N8950A-02

Modification Recommended Service Note

N8950A Autoranging System DC Power Supply

Figure 1: Stuck Keypad

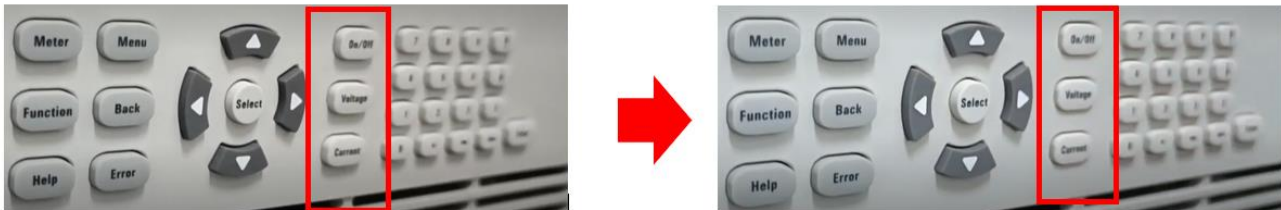
Unit in the above serial number range may intermittently encounter keypad stuck when pressing the keys at front panel. Figure 1 shows an example of a stuck keypad, which could occur with any of the keys.

Please send to service center for keypad replacement. Kindly contact Keysight Technologies Customer Contact Center at www.keysight.com/find/contactus for sending the affected unit back.
